PRELIMINARY ENGINEERING
IMX-080-3(315)128--02-77
POLK COUNTY

PLANS OF PROPOSED IMPROVEMENT ON THE
PRIMARY ROAD SYSTEM
POLK COUNTY
PRELIMINARY ENGINEERING

I-35/80 from IA 141 in Urbandale to E of I-35/80/235
 Northeast Mixmaster System Interchange (NEMM)

FIELD EXAM CHECKLIST

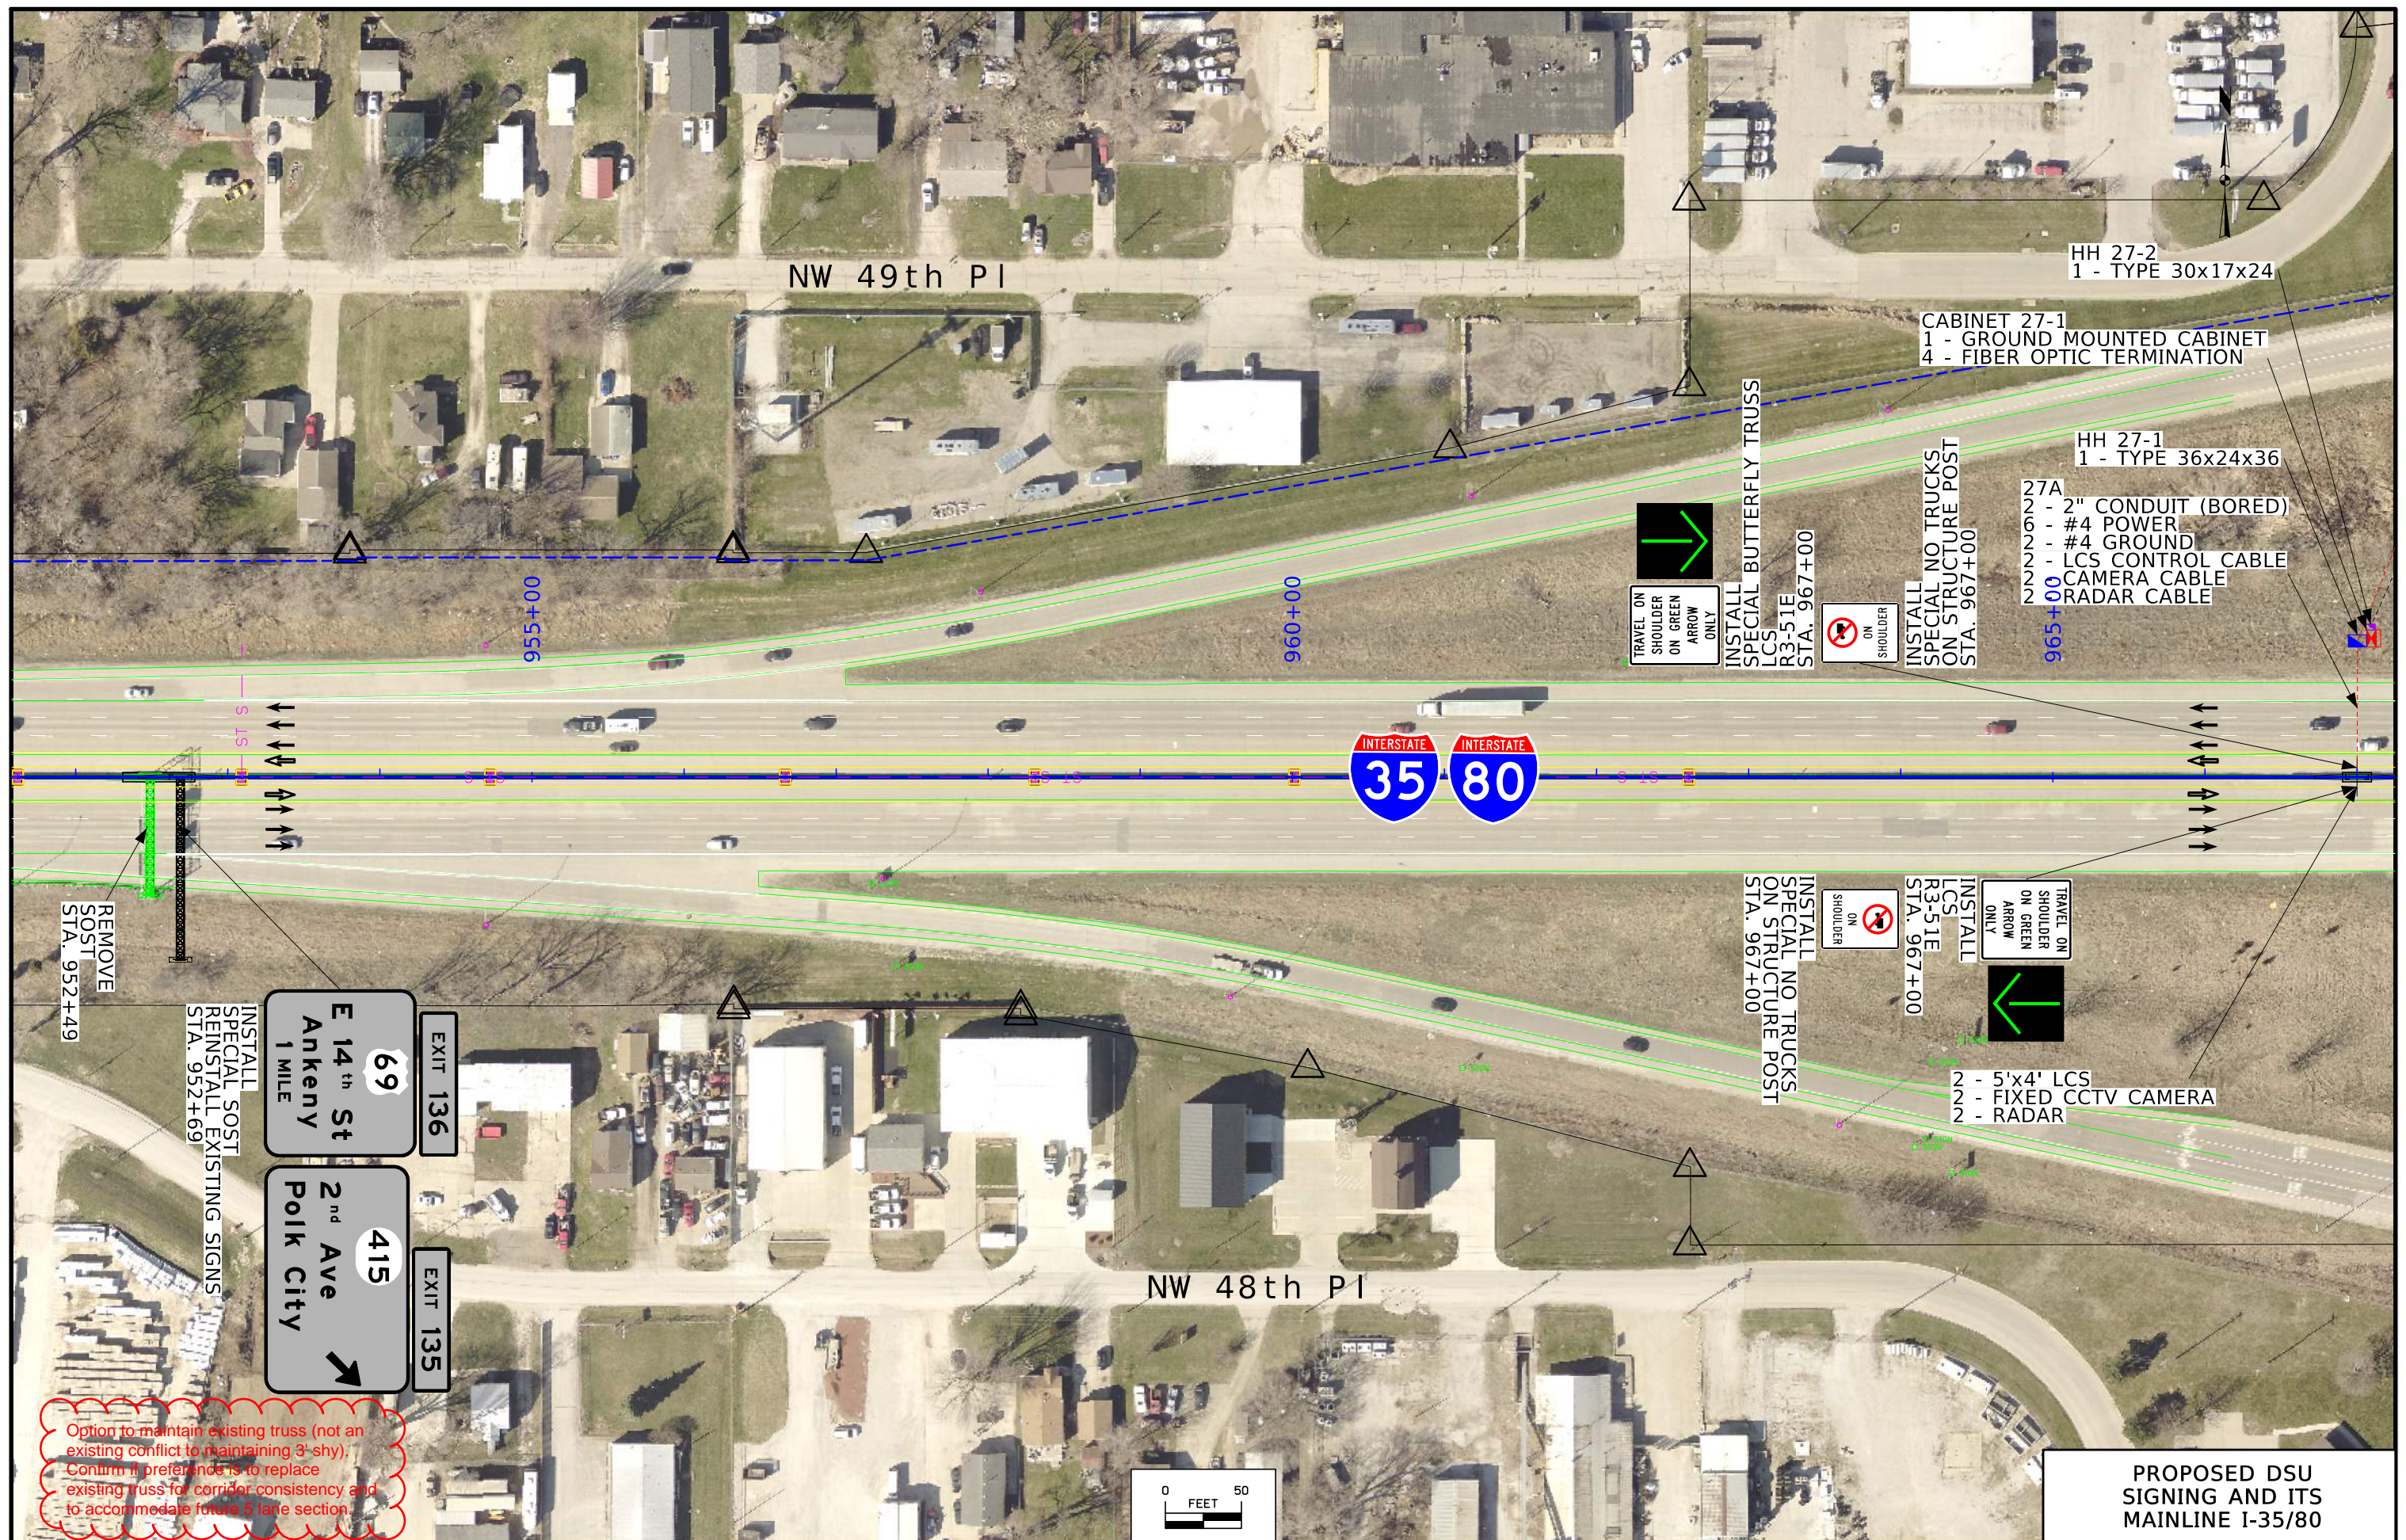
Option to maintain existing truss (not an existing conflict to maintaining 3'-shy). Confirm if preference is to replace existing truss for corridor consistency and to accommodate future 5 lane section.

PROPOSED DSU
SIGNING AND ITS
MAINLINE I-35/80

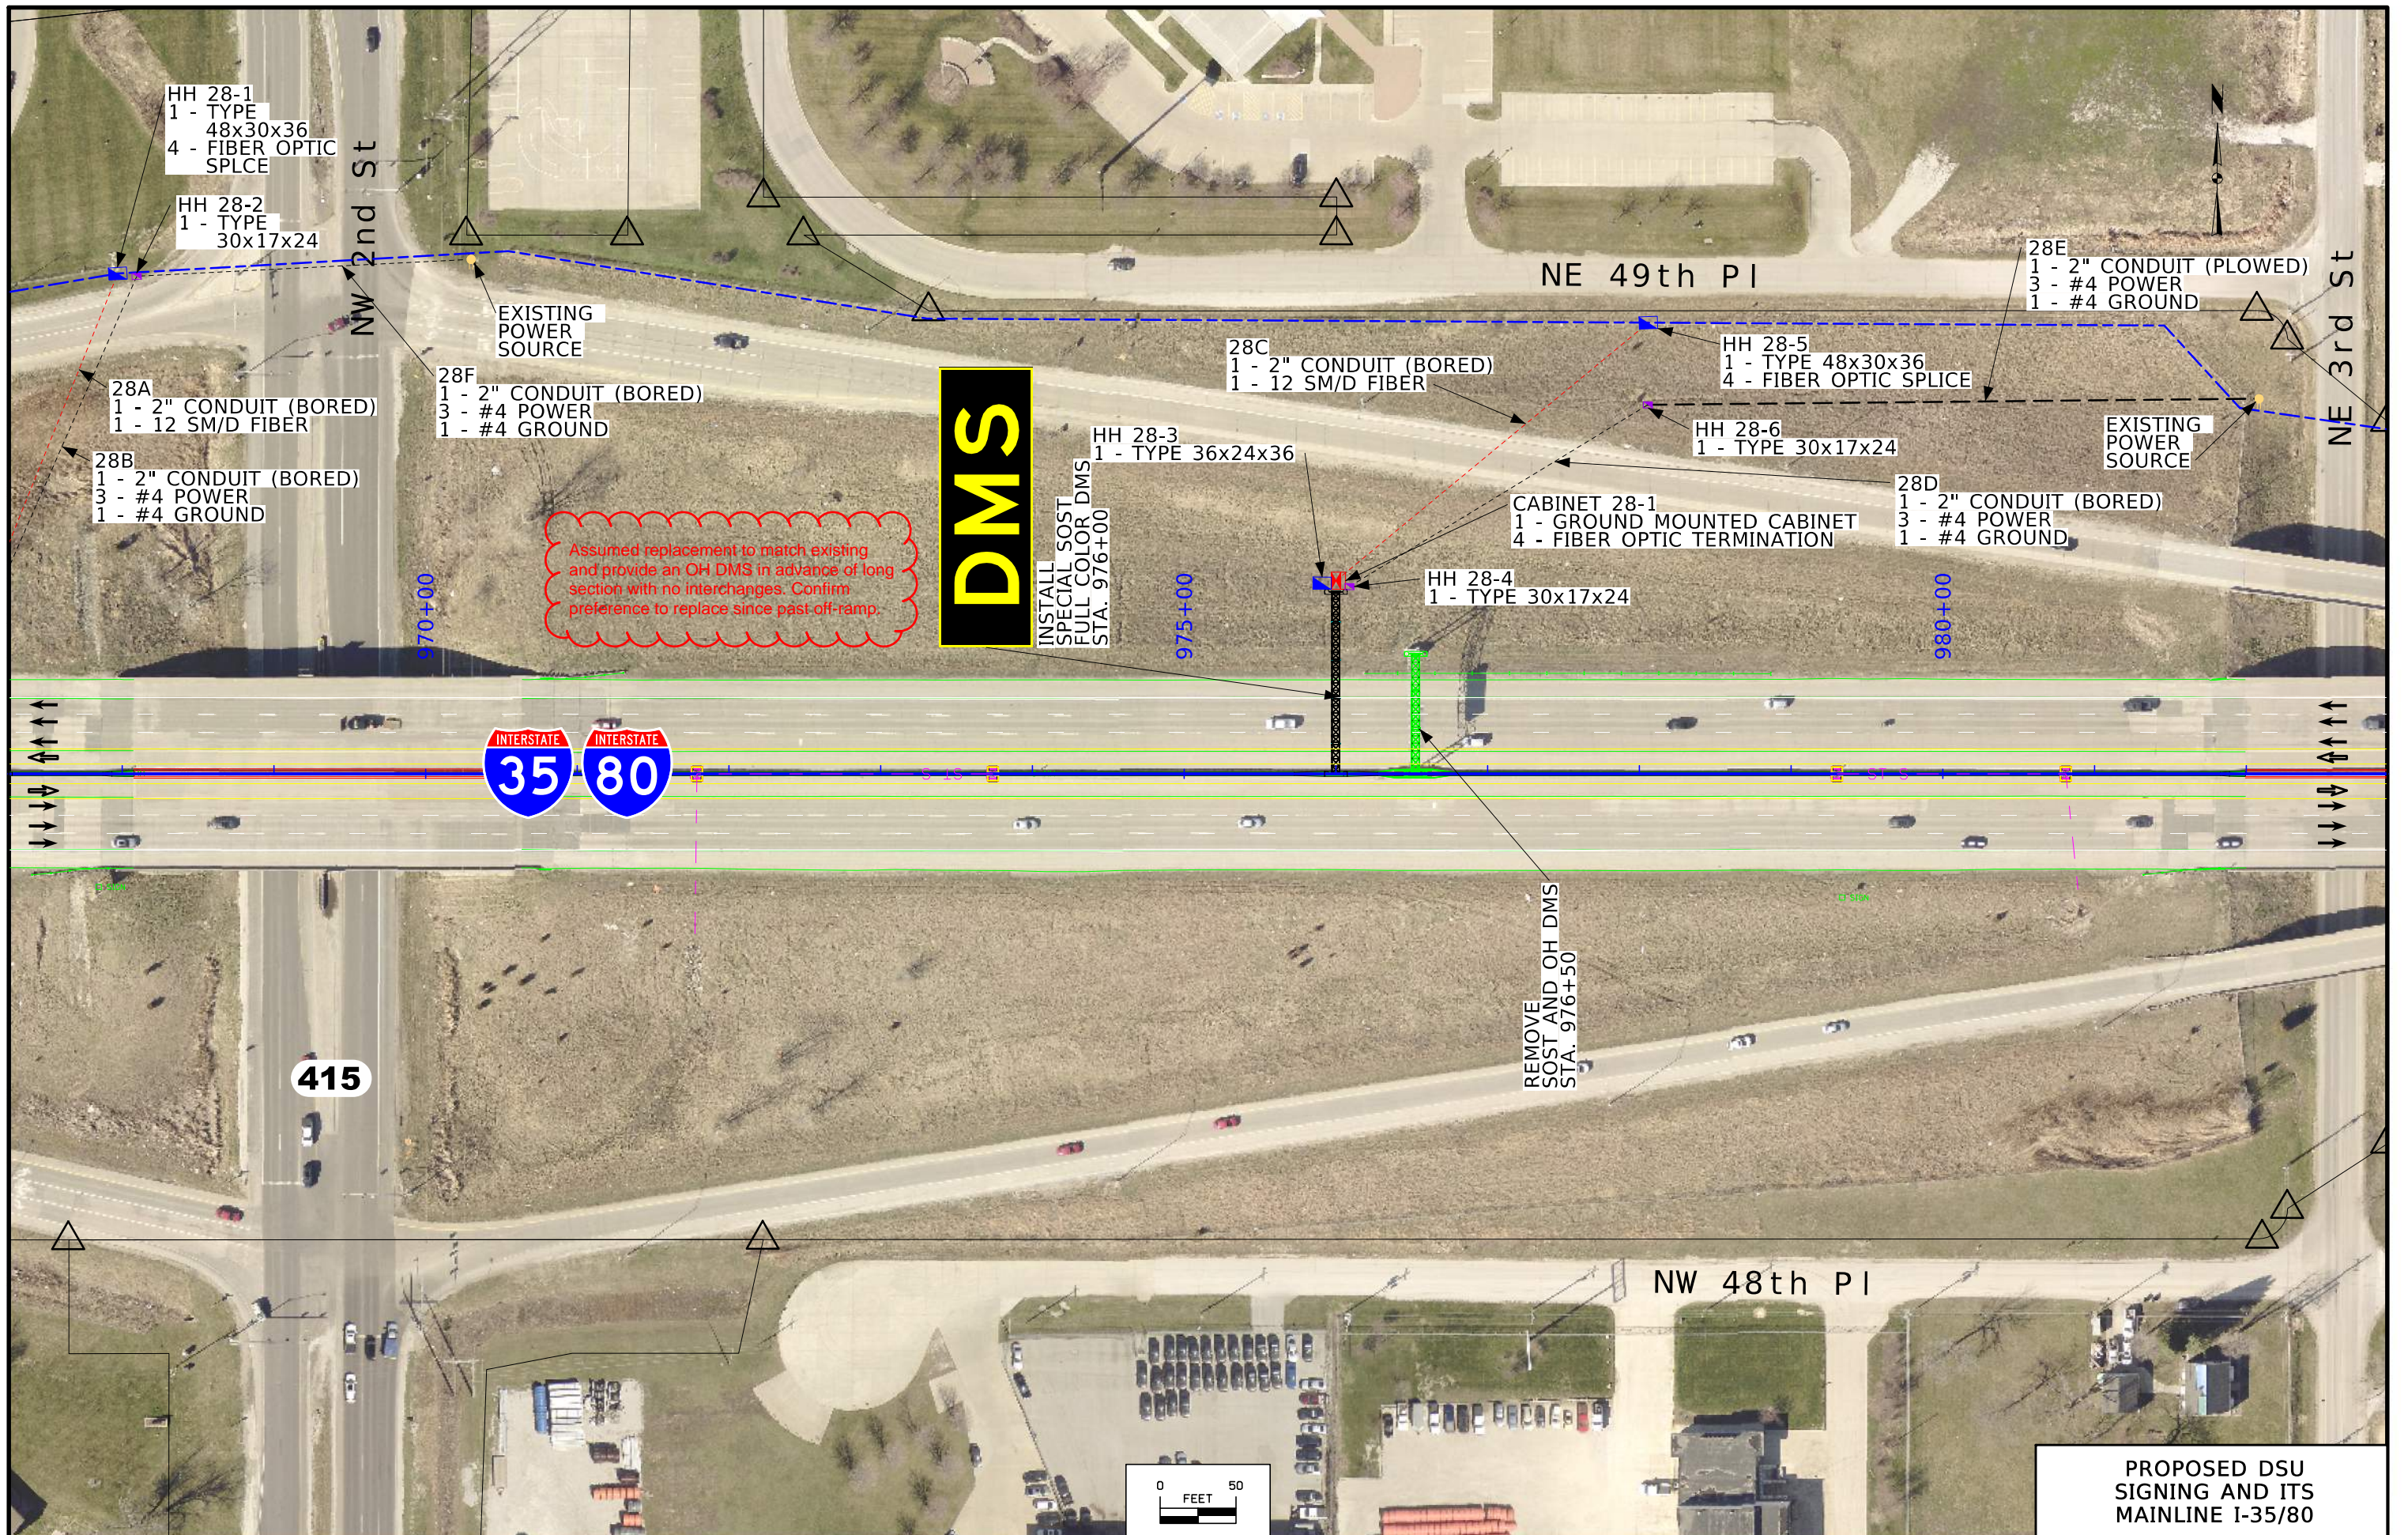
Assumed replacement to match existing and provide an OH DMS in advance of long section with no interchanges. Confirm preference to replace since past off-ramp.

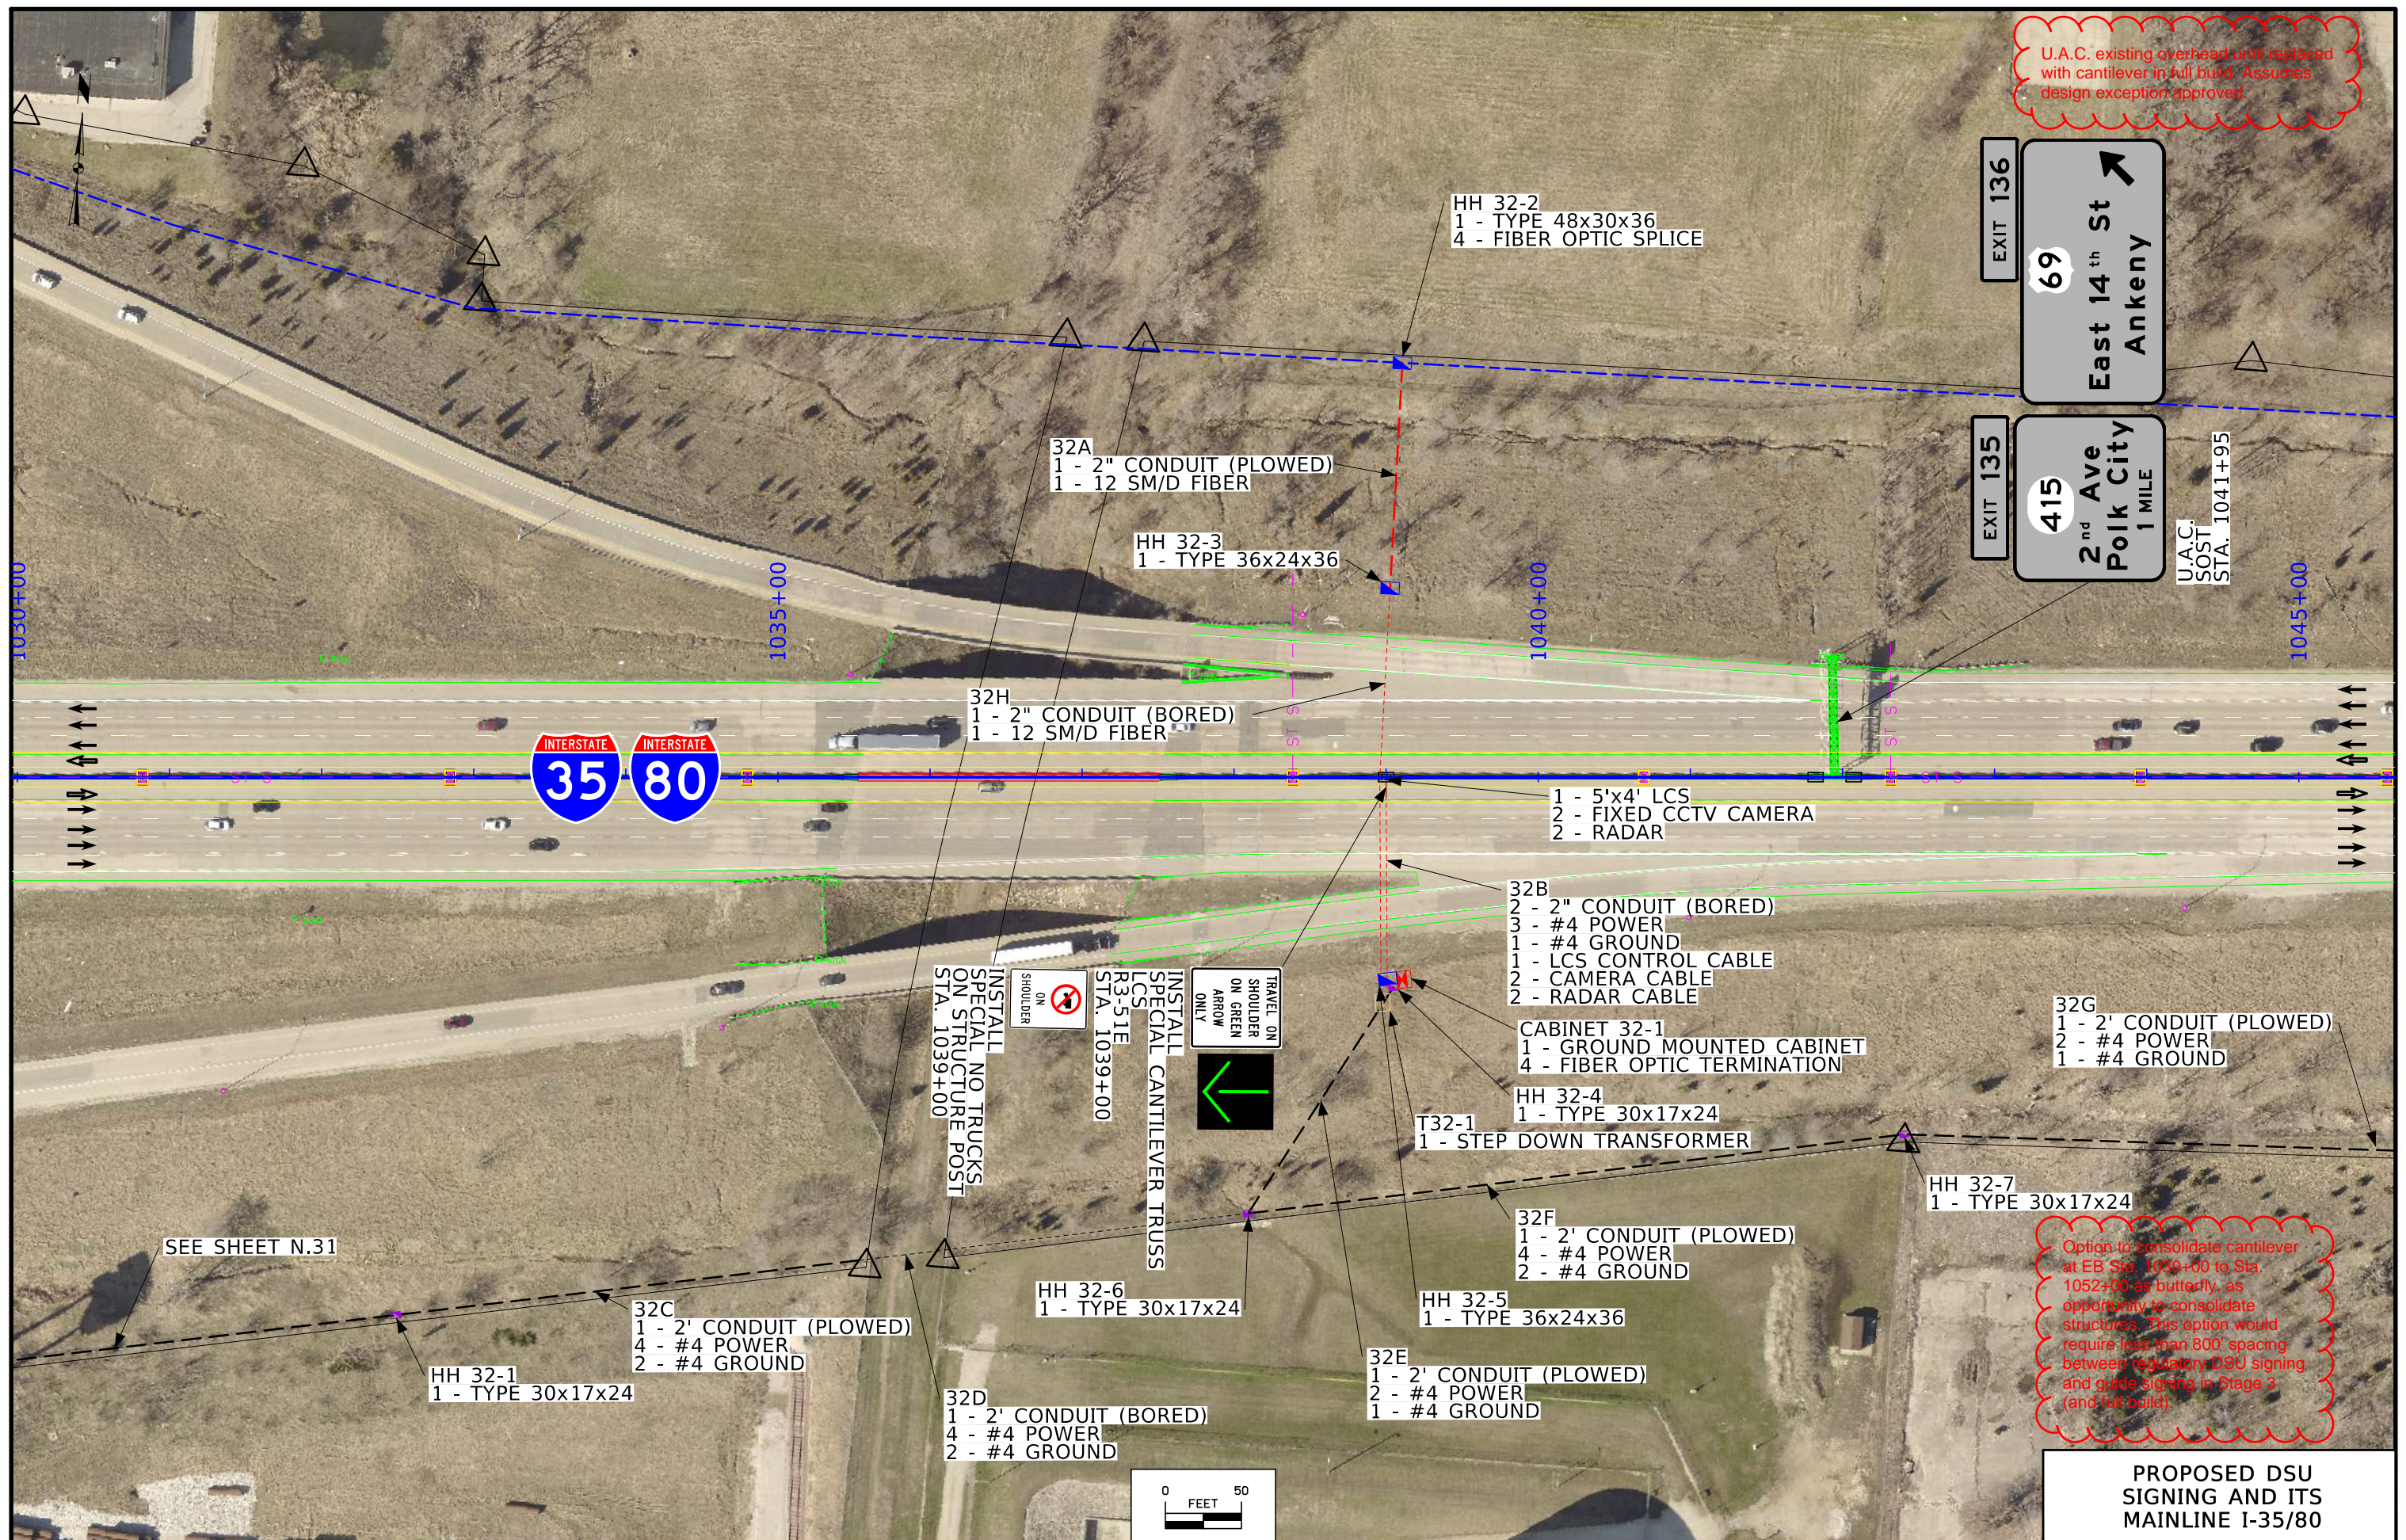
U.A.C. existing overhead until replaced with cantilever in full build. Assumes design exception approved.

Option to consolidate cantilever at EB Sta. 1039+00 to Sta. 1052+00 as butterfly, as opportunity to consolidate structures. This option would require less than 800' spacing between regulatory DSU signing and guide signing in Stage 3 (and full build).
